MERCURY MARINER

Service Bulletin

Bulletin No. 2007-08

Dressed Powerheads (3.0 Liter OptiMax)

Air pressure regulator location on port fuel air

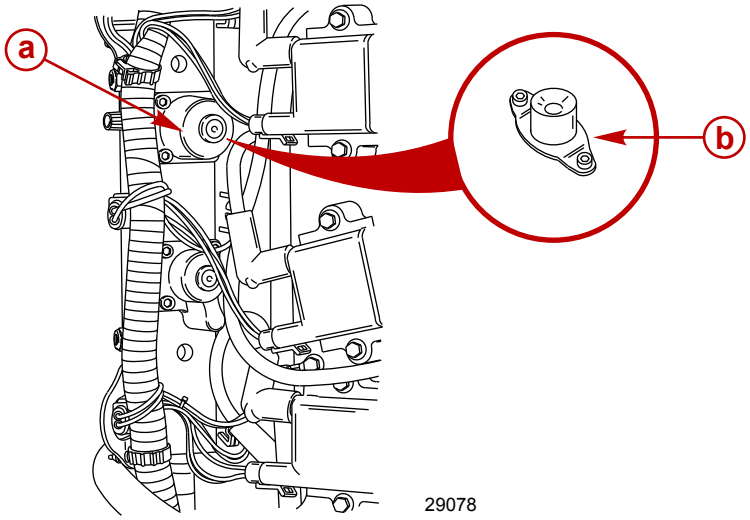
The original 2001 and 2002 dressed powerheads used a one piece air regulator on the port fuel rail. The 2003 and newer models use a multi-piece regulator.

a - Multi piece air regulator on port fuel rail 2003 and newer

b - One piece air regulator on 2001/2002 models

If a multi-piece regulator is found on the port rail, order replacement powerhead parts from the 2003 parts list.
